# SERVICE INSTRUCTION

## RUNNING MODIFICATIONS ON ROTAX® ENGINE TYPE 912 AND 914 (SERIES) SI-25-1997 R8

Running modifications on ROTAX® engine type 912 and 914 (series).

fig. 3

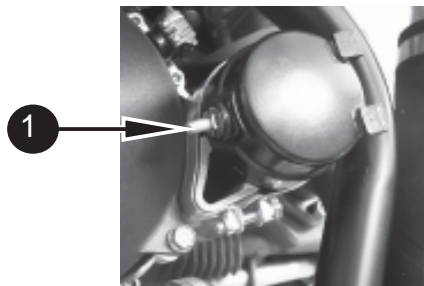
The trigger coil kit part no. 965175 and the trigger coil for the rev-counter part no. 264080 will no longer be supplied. For parts service the trigger coil kit part no. **965176** and rev-counter trigger coil part no. **264086** have to be ordered. Old and new version of these items are interchangeable but take note of the different trigger gap.

Trigger gap for the NEW trigger coil: **0,3 - 0,4 mm (0,012 - 0,016 in.)**

◆ NOTE: The fixation of the trigger coil is changed from cylindrical bore with centering to elongated bore. Take care of correct assembly. (see fig. 21)

fig. 4

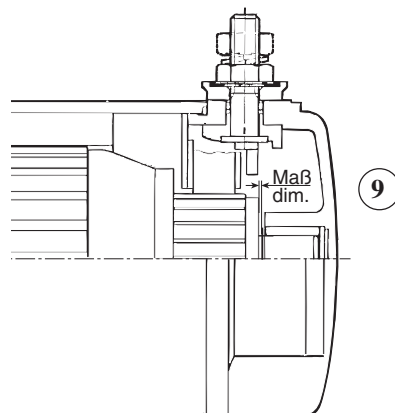
The tightening torque of the cable connections on starter relay part no. 992819 and on electric starter has been reduced from 8 Nm (70 in.lb) to **4 Nm** (35 in. lb). The new tightening torque must be considered at assembly of all 912 and 914 engines.

Furthermore, if using the ROTAX<sup>®</sup> engine suspension frame, the fitting position of the electric starter is limited to only one position instead of formerly two positions, as otherwise the terminal (1) would collide with the engine frame.

fig. 8

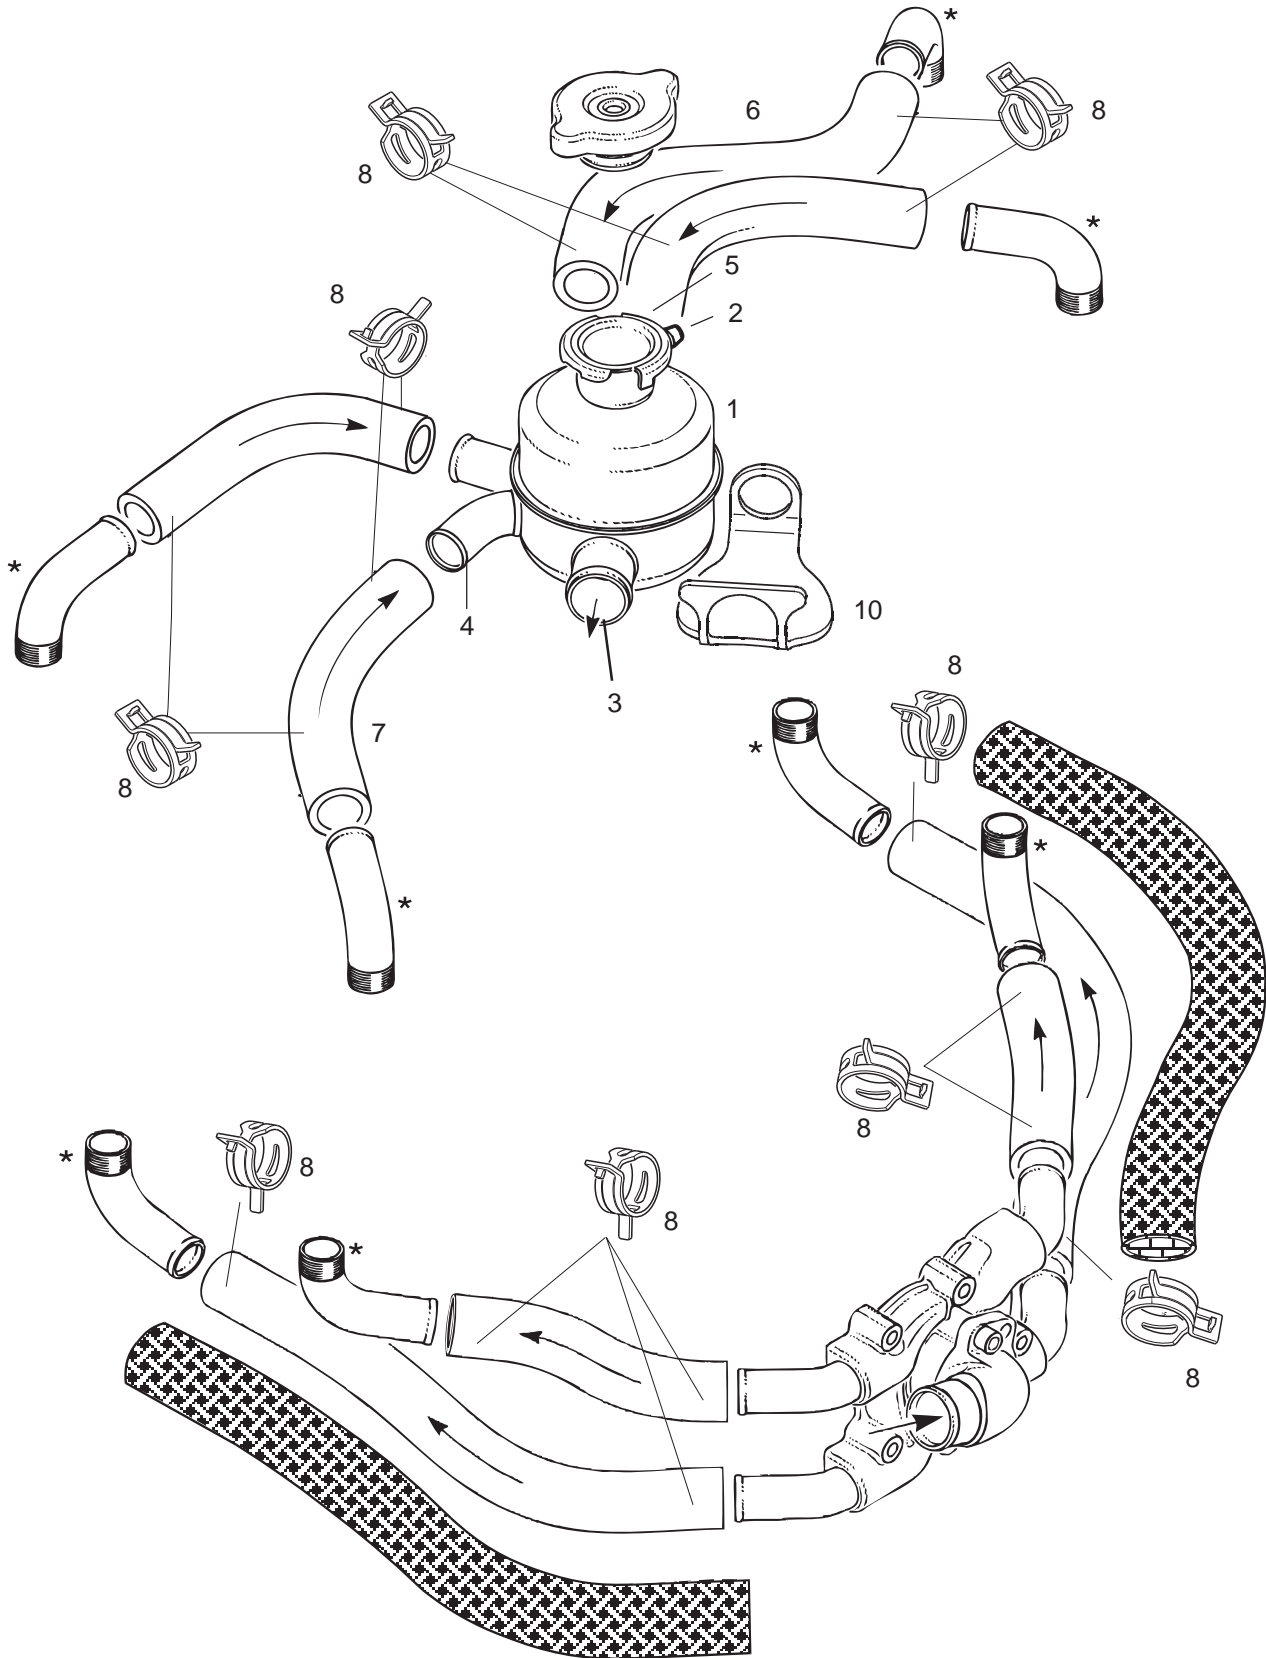
Owing to experience the following tolerance has been changed. Observe this change at engine repair / general overhaul:

| Electric starter         | new                                    | wear limit            |
|--------------------------|--|-----------------------|
| Rotor, axial clearance ⑨ | .. 0,1 ÷ 0,4 mm<br>(0,004 - 0,016 in.) | 0,7 mm<br>(0,028 in.) |

fig. 5

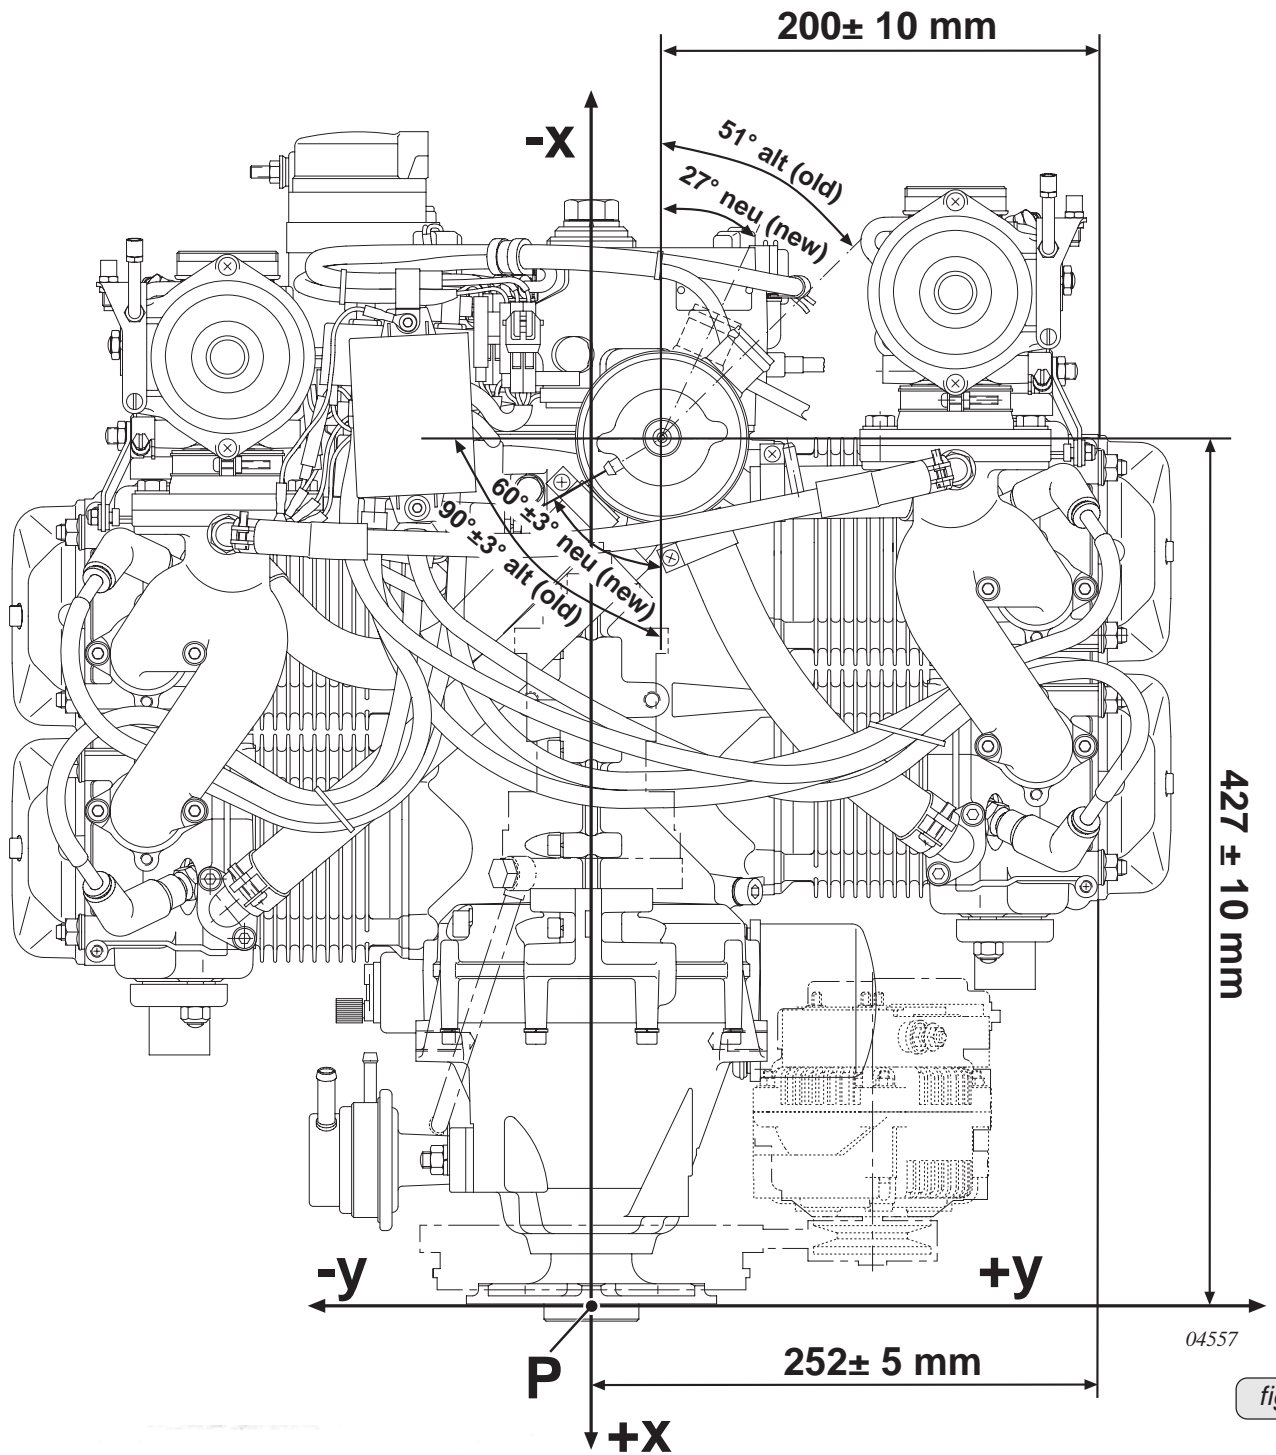
In the course of further development and standardization the position of the expansion tank (1) has been optimized!

- position of connection (2) to overflow bottle (from 0° to 30±3°)
- position of connection (3) to radiator (from 51° to 27±3°)
- angle of inlet socket (4) from cylinder 4 (34° inclined)
- length of inlet socket (5) from cylinder 3 (length increased by 13,4±3 mm)
- length of coolant hose (6) from cylinder 1 (length increased from 270 mm to 285 mm)
- length of coolant hose (7) from cylinder 4 (shortened from 100 mm to 85 mm)
- new spring type hose clamps (8) to attach the coolant hoses (expansion tank and water pump)

fig. 7

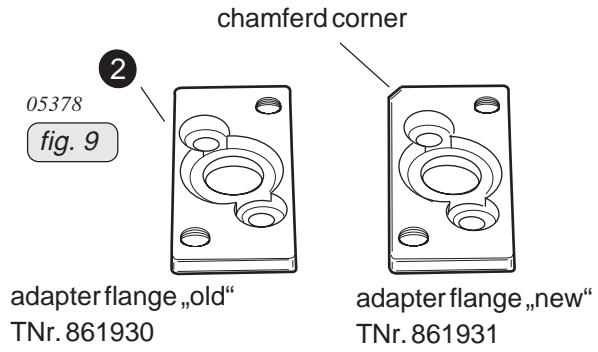
- Inspect the rubber plate (10).
- ◆ **NOTE:** Wear of up to 1 mm from original thickness can be tolerated!
- Install the coolant hose (6) 285 mm to cylinder 1 and the new coolant hose (7) 85 mm to cylinder 4. For attaching all the coolant hoses from expansion tank, water pump, cylinders, use the new spring type clamps.
- **ATTENTION:** Take care of appropriate slip-on length of the coolant hoses on the corresponding connection socket. Verify tight fit of clamps and hoses and check for leakage. Always fit the clamps such that they can not wear on any component and use a suitable tool (see fig. 7) for fitting them.

00052  
fig. 10

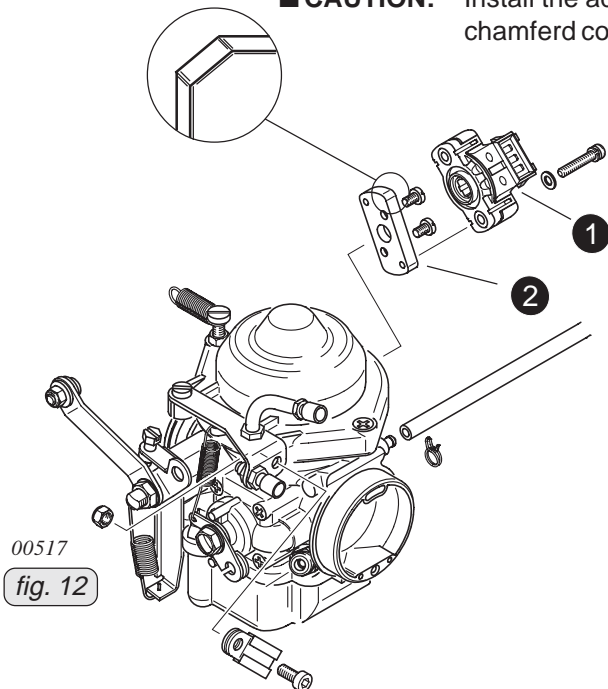
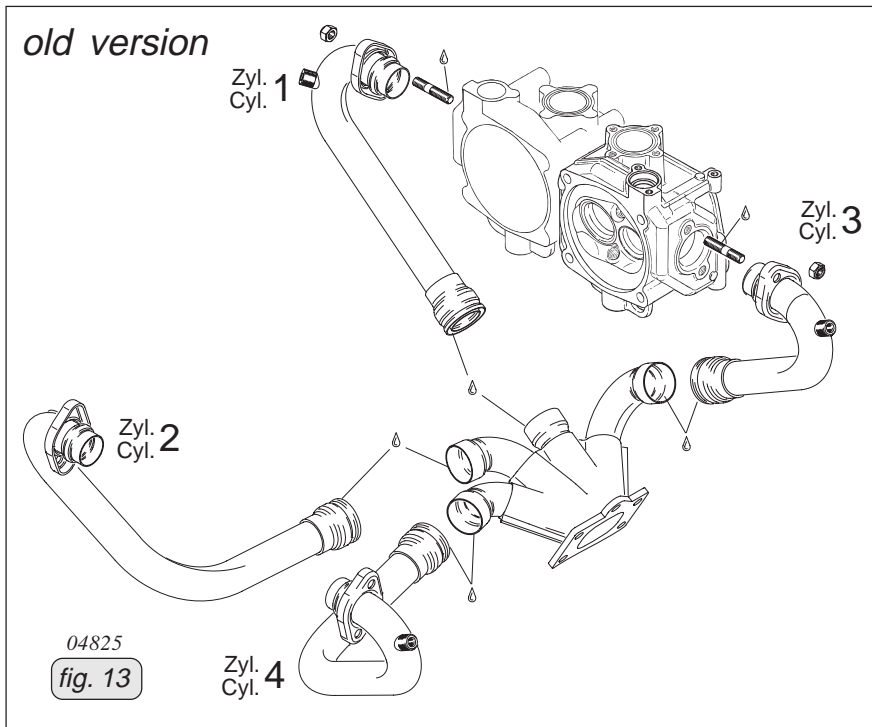
**Resistance between the terminals (5) and (6):**(see fig. 10)

Throttle **open** (throttle lever pos. 115%): value must be less than 3,8 kΩ .

Throttle **closed** (throttle lever pos. 0%): value must be more than 100 Ω.

05735  
fig. 16

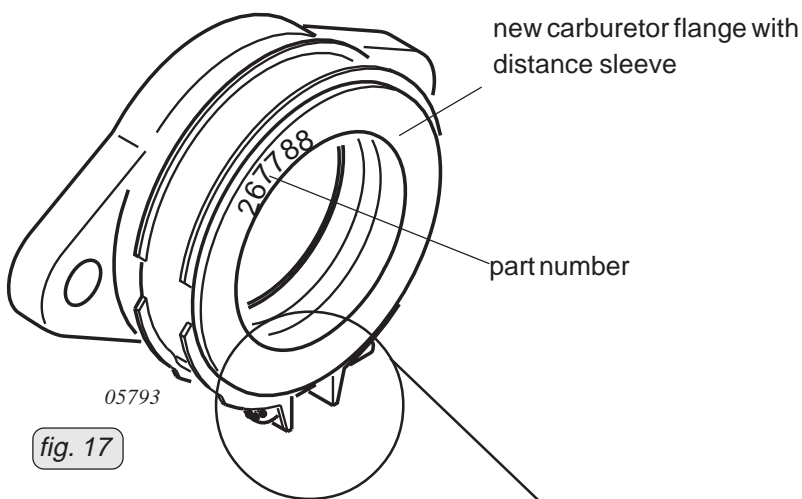
Owing to continuous further development and standardization in other engines the radiator cap with higher 1,2 bar (18 psi) opening pressure have been introduced.

05793  
fig. 17

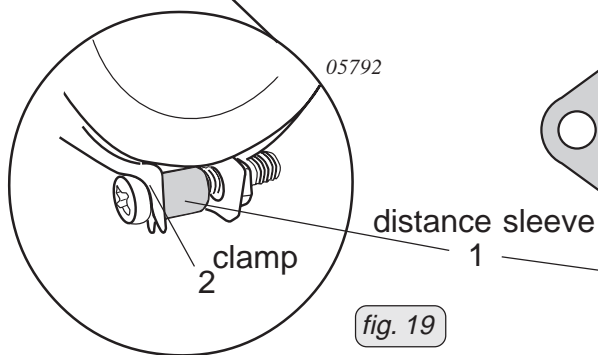
Owing to continuous further development and standardization in other engines the carburetor flange part no. 267788 introduced.

■ **CAUTION:** Due to differences in spacing **don't use** the distance sleeve (1) included in delivery of the carburetor flange part no. 267788 in combination with the carburetor flange part no. 267787.

■ **CAUTION:** **Don't use** aluminum insert included in delivery of the carburetor flange part no. 267785 or 267780 in combination with the carburetor flange part no. 267788.

fig. 19

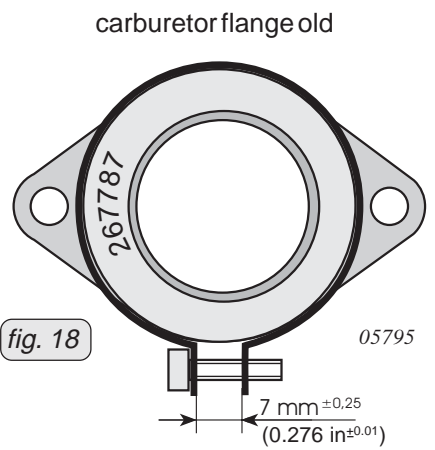
- At exchange, take care of the following:
- If replacement of part no. 267788 is necessary **both** carburetor flange are to be replaced per engine. (Do not mix new style with old style on the same engine)
- Tighten clamp (2) of the carburetor flange part no. 267788 with tightening torque 2.5 Nm (22 in.lb ) (see fig. 19) .

fig. 20 07138

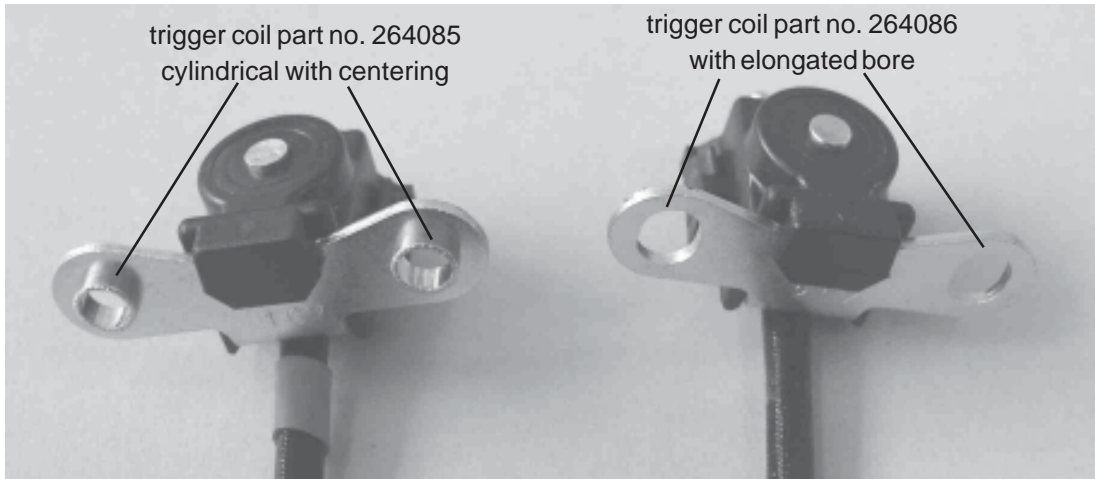
- The cylindrical fixation bore with centering are now carried out as elongated bore (fig. 20).
- 5 additional washers are necessary for fixation.

fig. 21

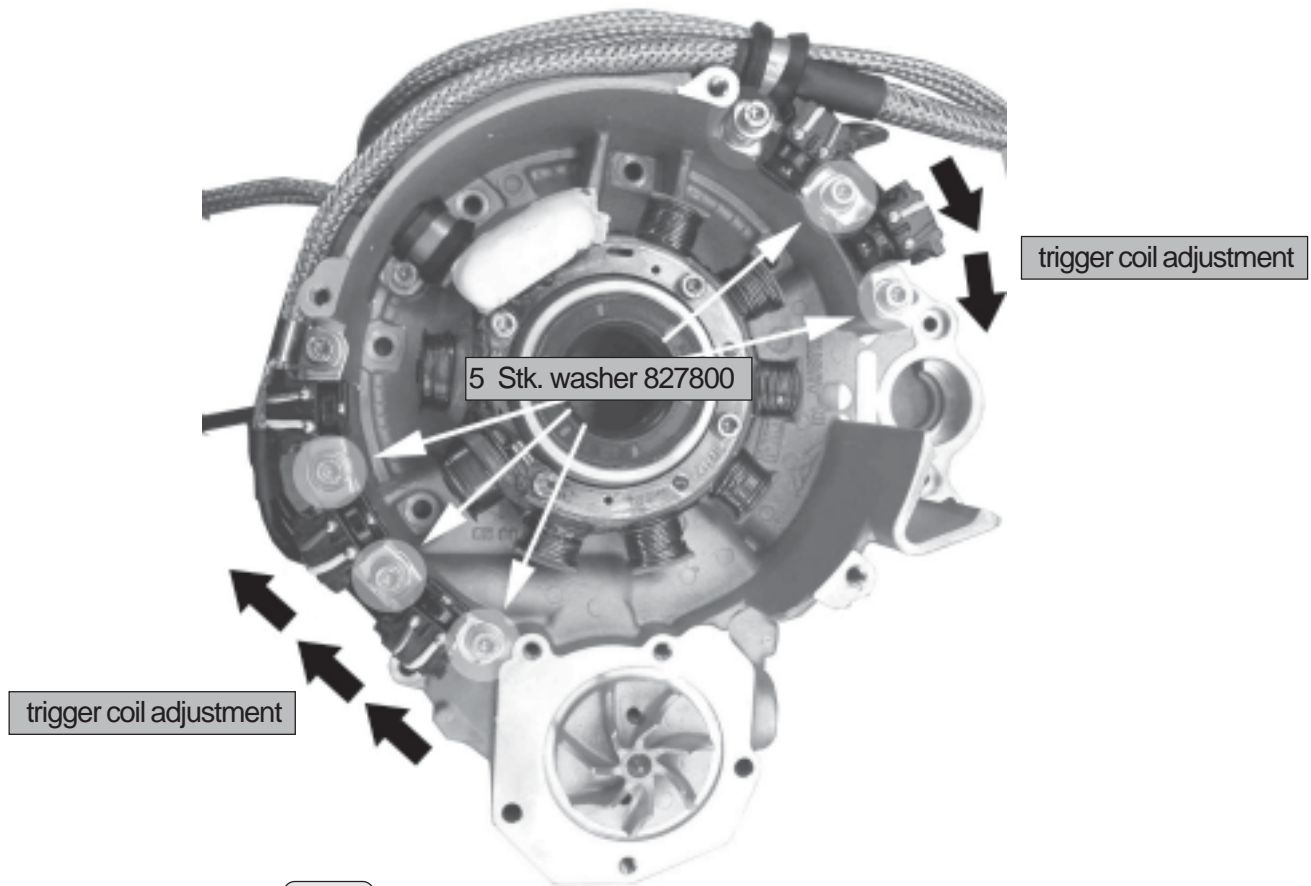
■ CAUTION: Because of no centering of the new trigger coil and clearance between screw and elongated bore, all trigger coils have to be pushed clockwise on block during adjustment of the trigger coil gap (see fig. 21).

fig. 22 06710

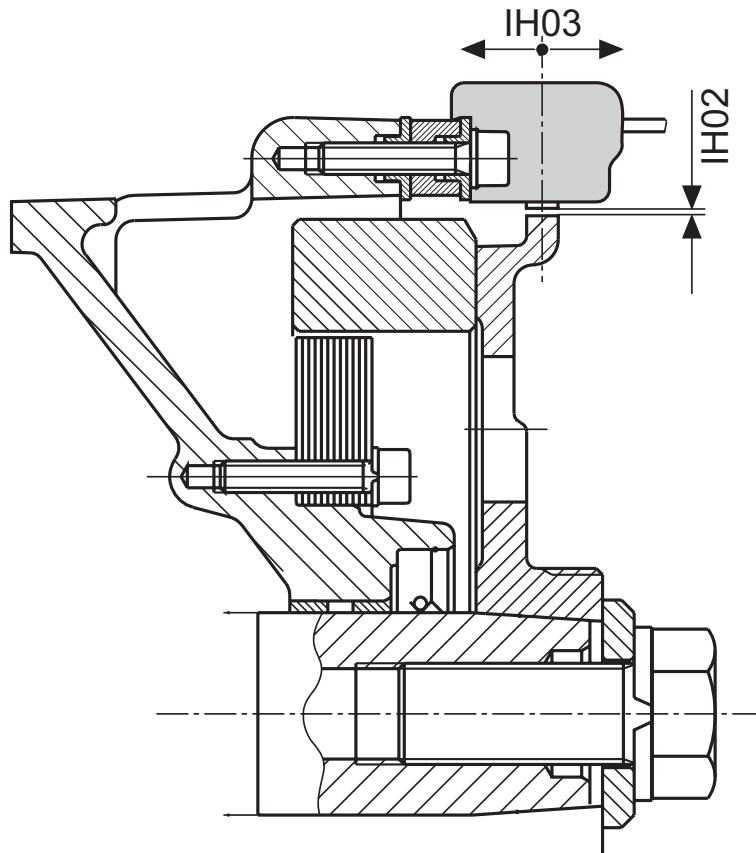
Trigger gap for trigger coil part no. 264086 (see fig. 22, measure IH02): **0,3 - 0,4 mm**
